Addendum No. 01

Date: April 09, 2026

Re: USOSM – Hopkin Oral Surgery
1377 E 3900 S
Salt Lake City, Utah 84124

Project No: 2025.79

1 DOOR # WINDOW TAG PLAN
 A-7 3/16" = 1'-0"

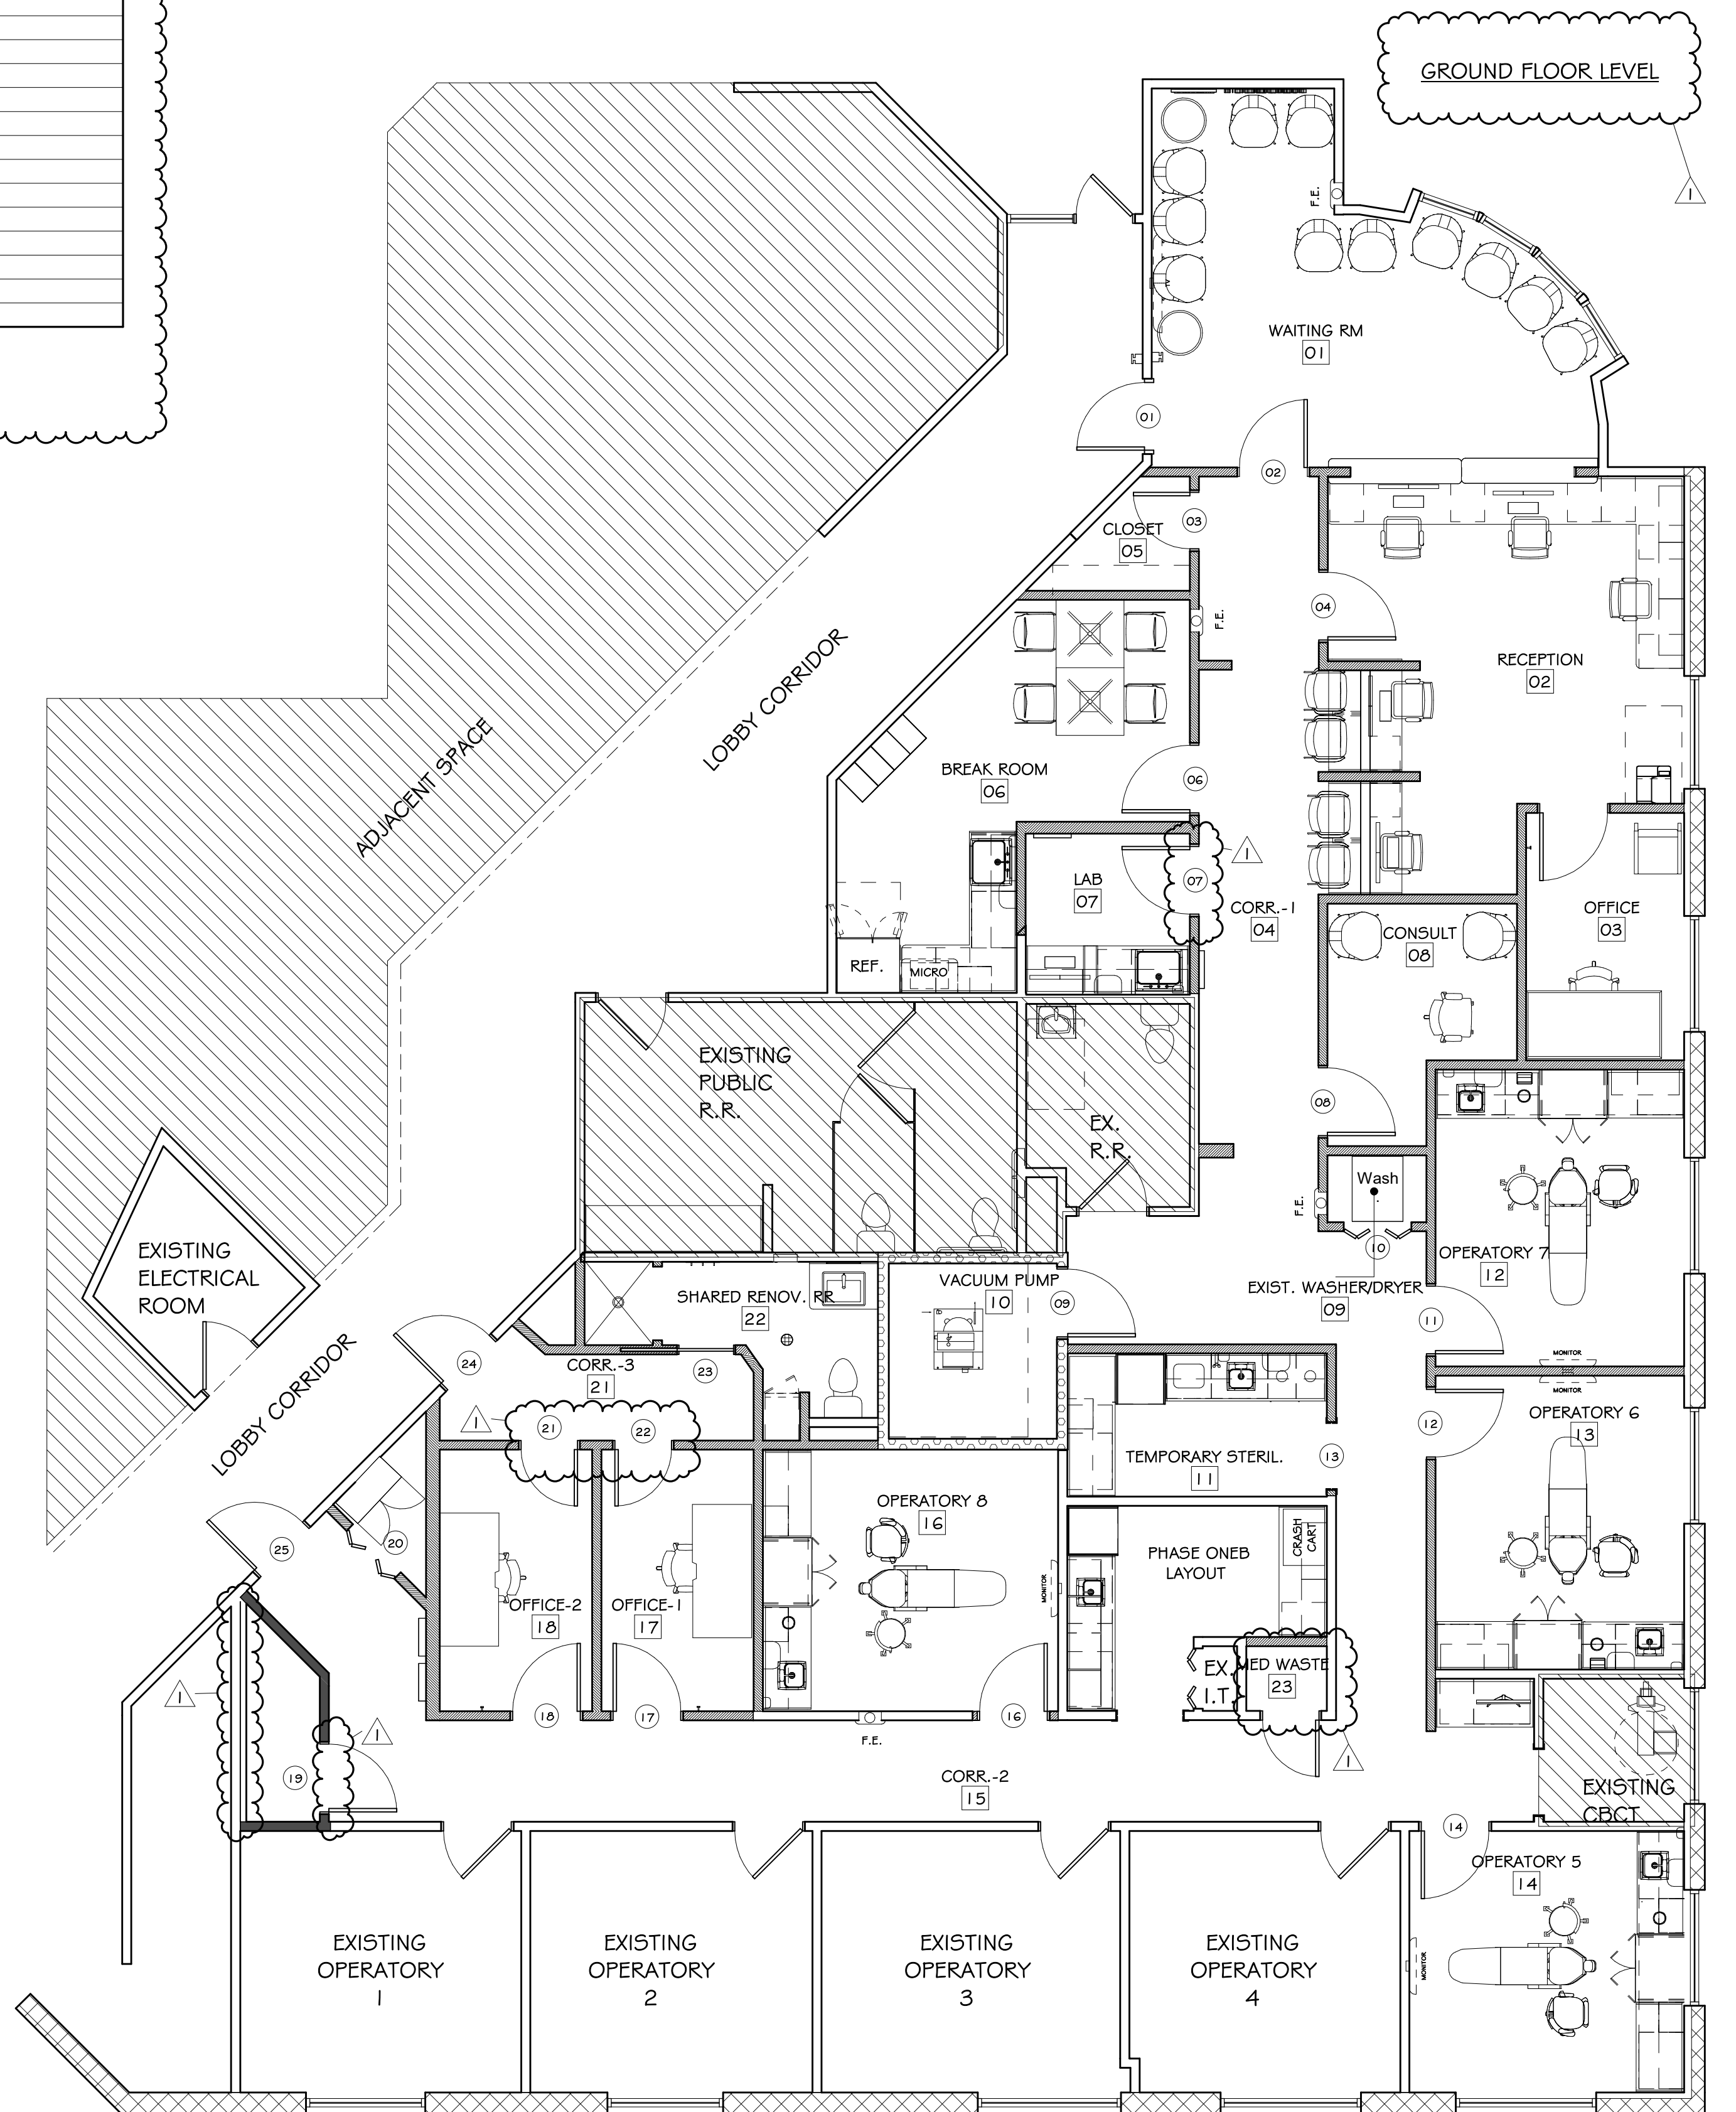
10. Revision:
Sheet A-7:
- A. Updated the door and frame schedule. (Architectural Clarification)
 - B. Updated the door type elevations. (Architectural Clarification)

- C. Updated the Door Finish hardware schedule. (Architectural Clarification)
 - D. Added note to indicate which floor level the floorplan is on.
(Permit Response)

- E. Added 1hr fire rated shaft wall assembly to gas room (19).
(Architectural Clarification)
11. Revision:
Sheet A-8:
- A. Updated reflected ceiling legend. (Architectural Clarification)

1 PLUMBING - DW&V
P-2 3/16\" = 1'-0"

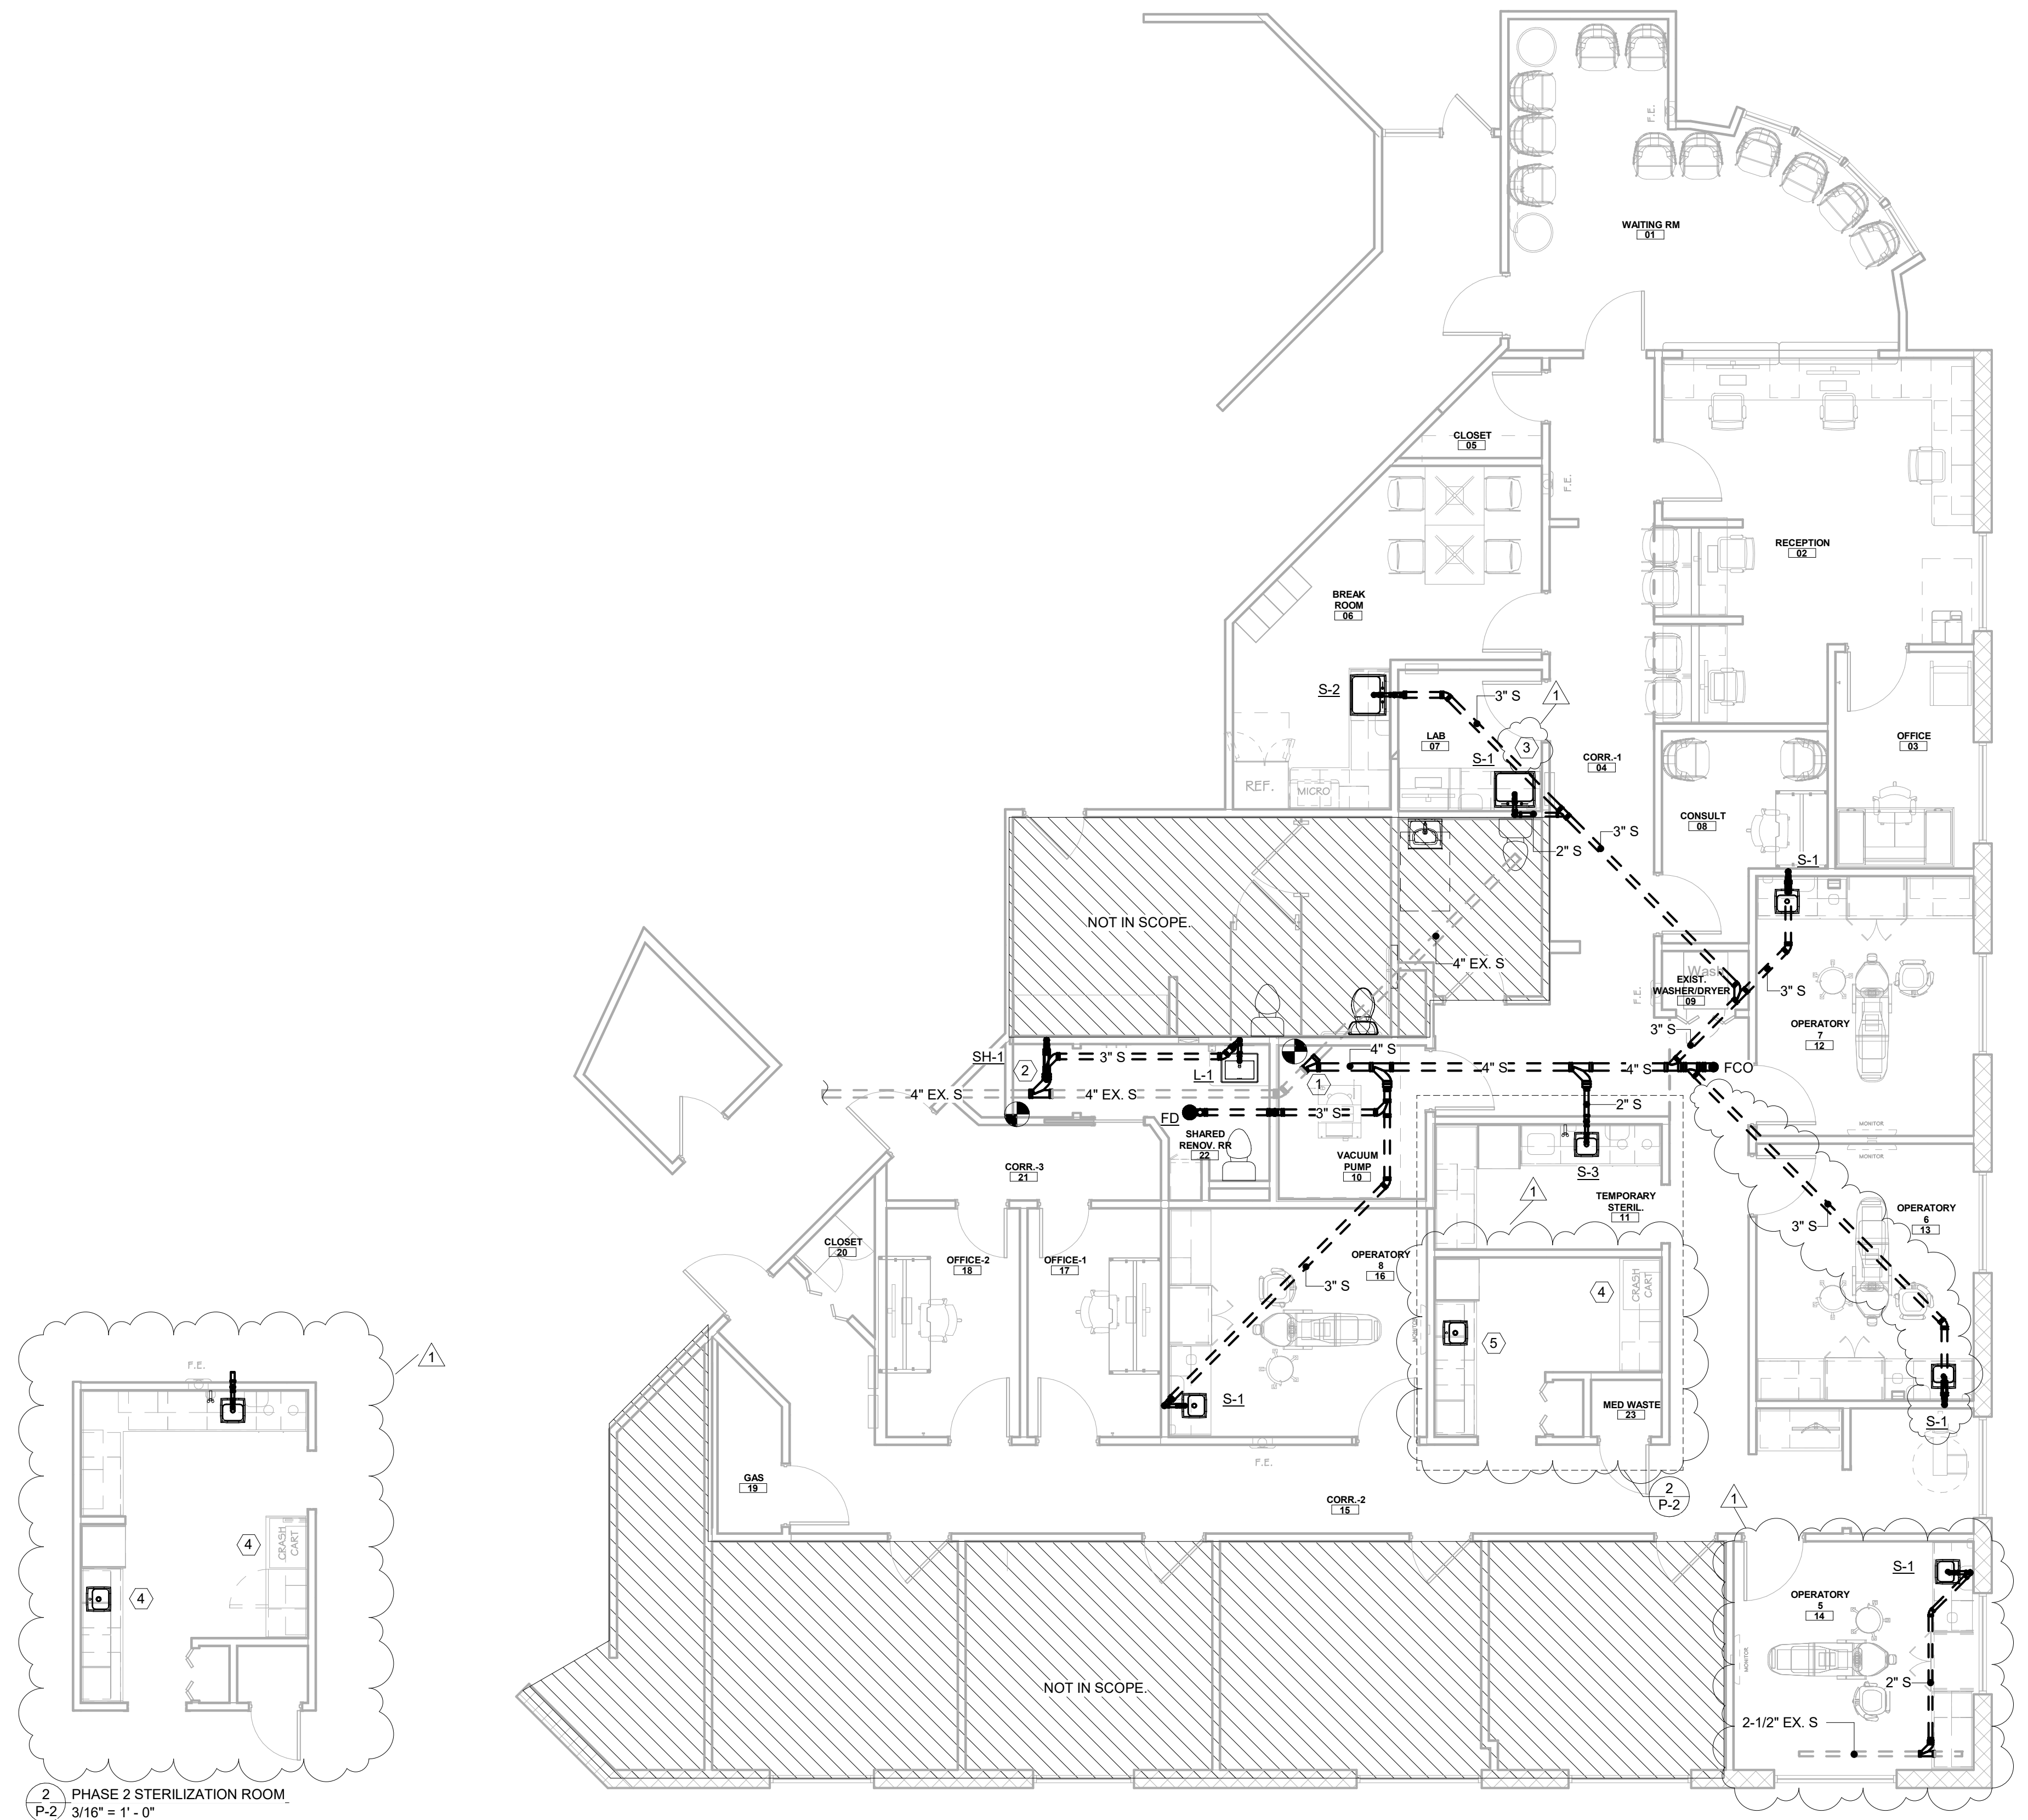
- D. S-1 moved in operatory 6. (Engineer Clarification)
15. Revision:
Sheet P-3
- A. Changed connection to S-1 to existing $\frac{3}{4}$ " piping within space. (Engineer Clarification)

1 PLUMBING - SUPPLY
P-3 3/16" = 1'-0"

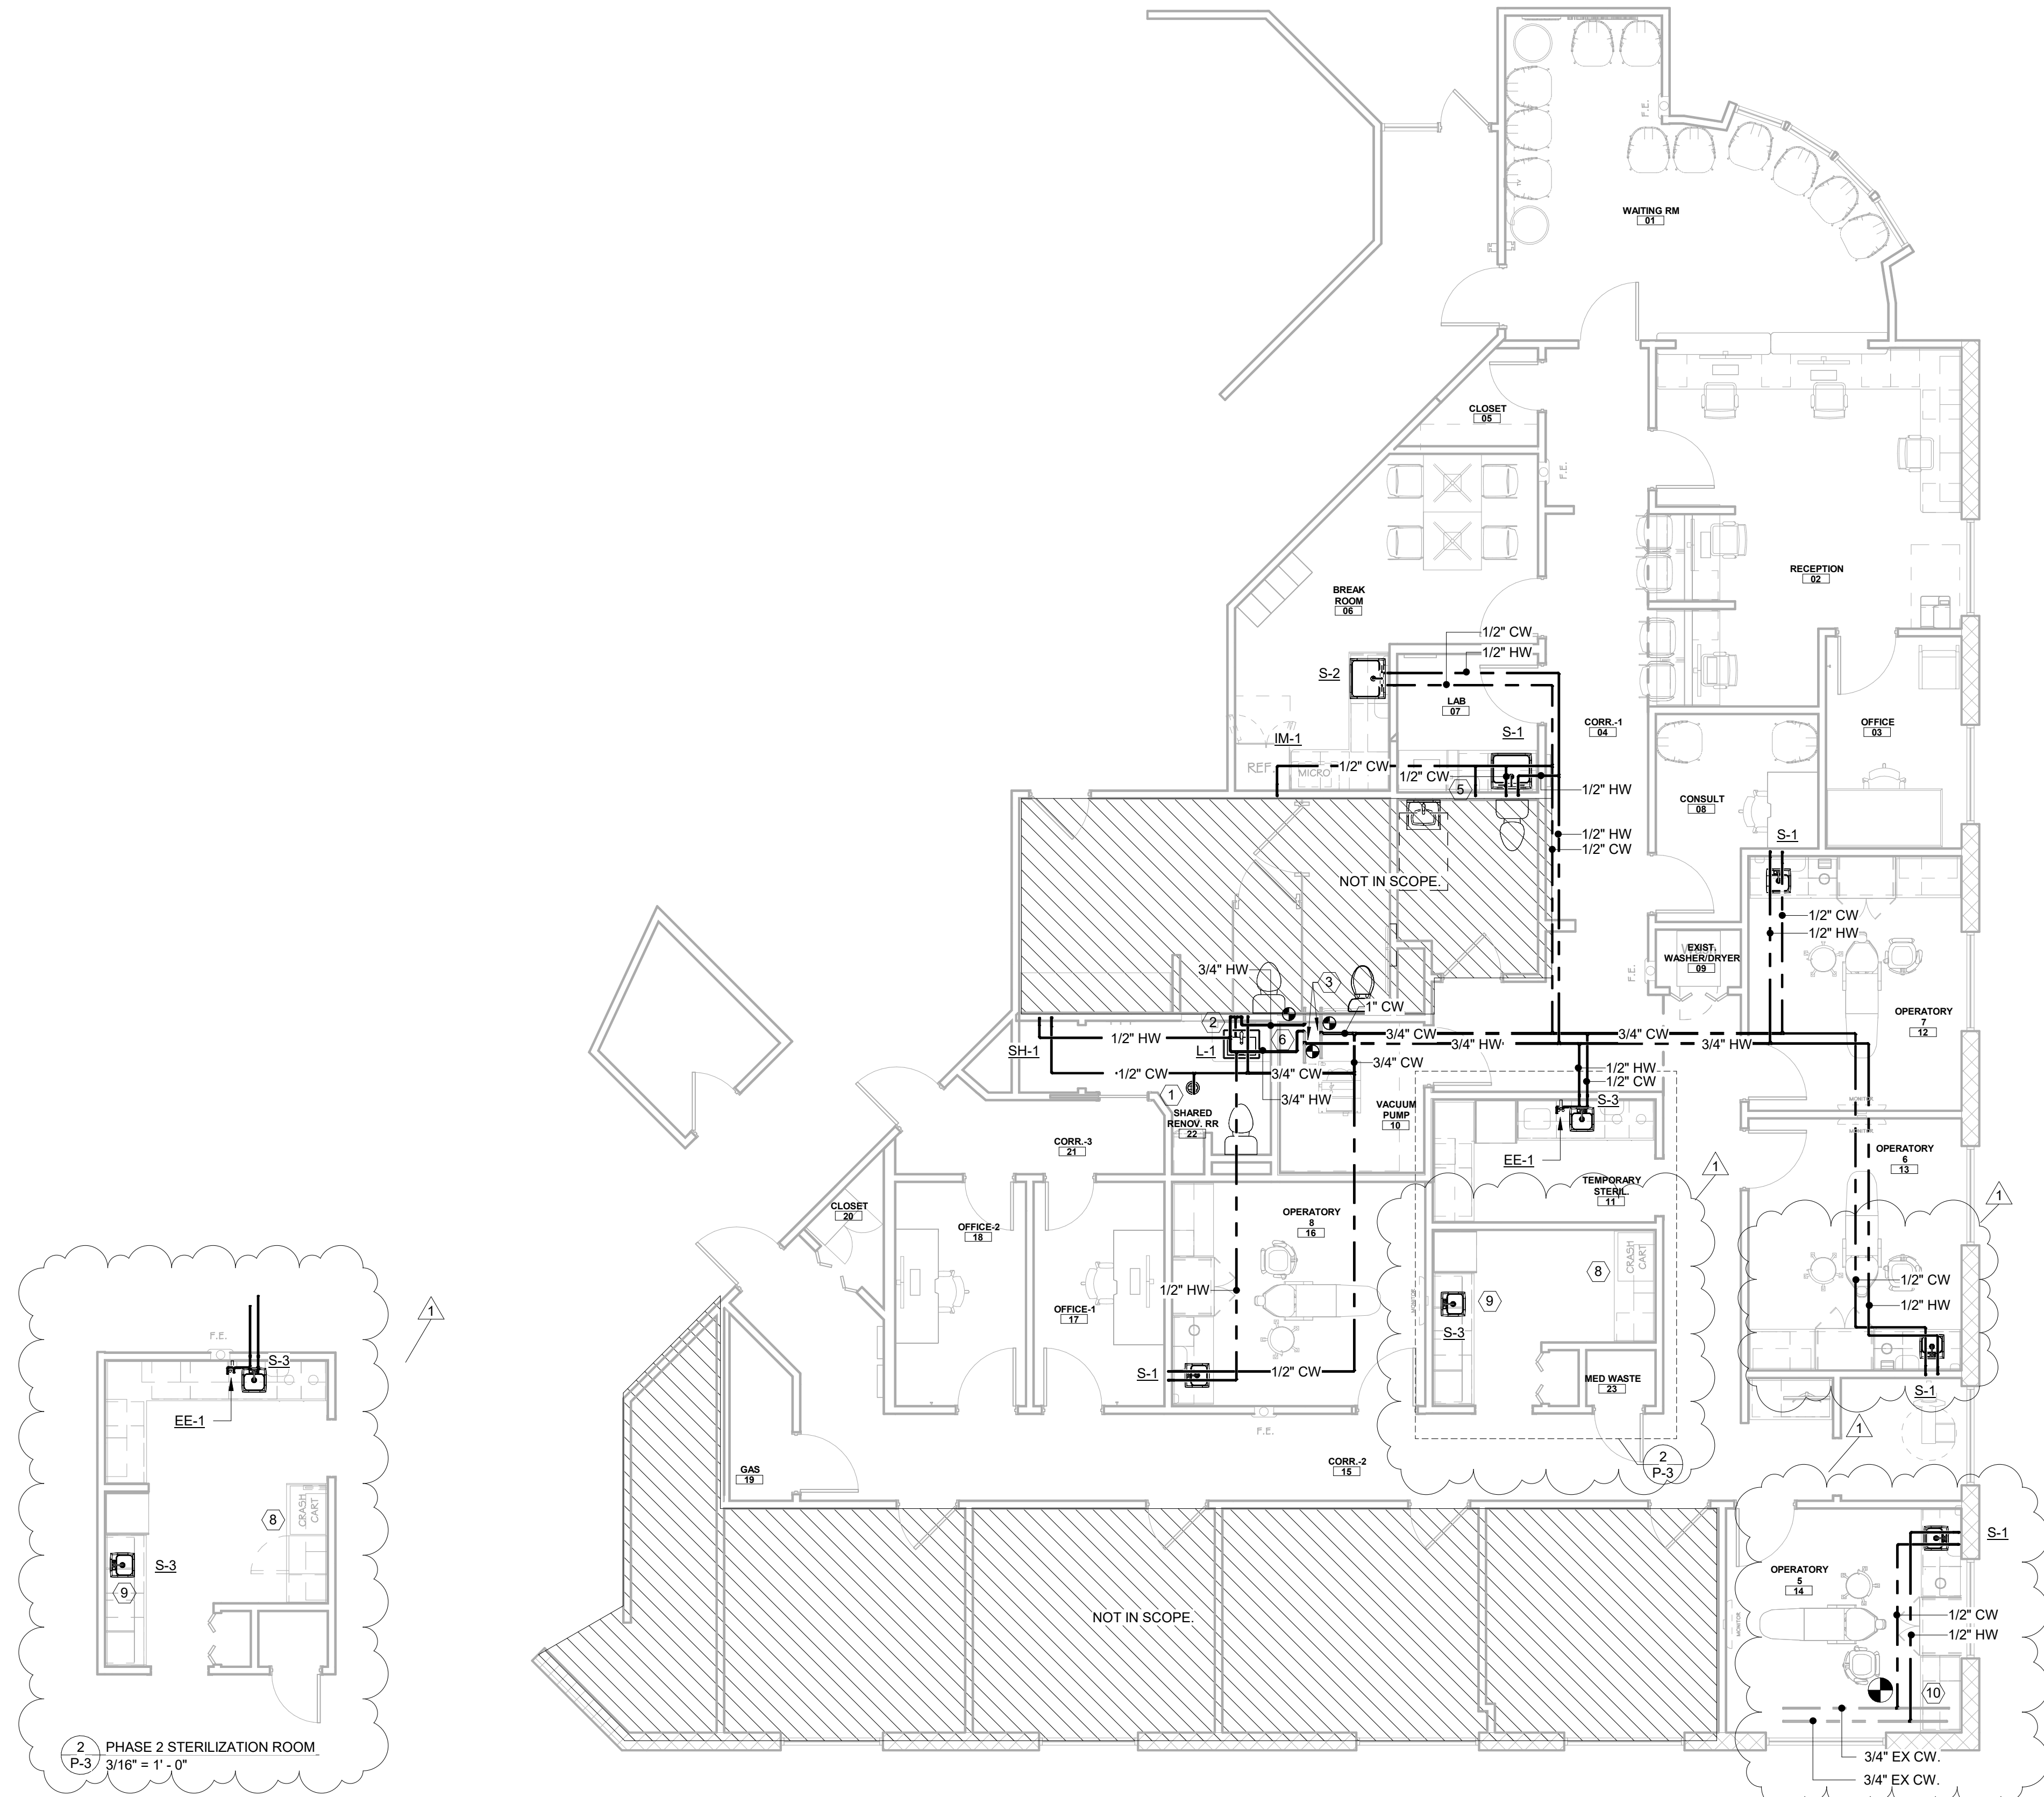
- B. Added a single sprinkler head to gas closet. (Permit Response)
 - C. New keyed notes calling out for the demolishing of Fixtures. (Engineer Clarification)

- D. New keyed notes reflecting change. (Engineer Clarification)
 - E. S-1 moved in operatory 6. (Engineer Clarification)
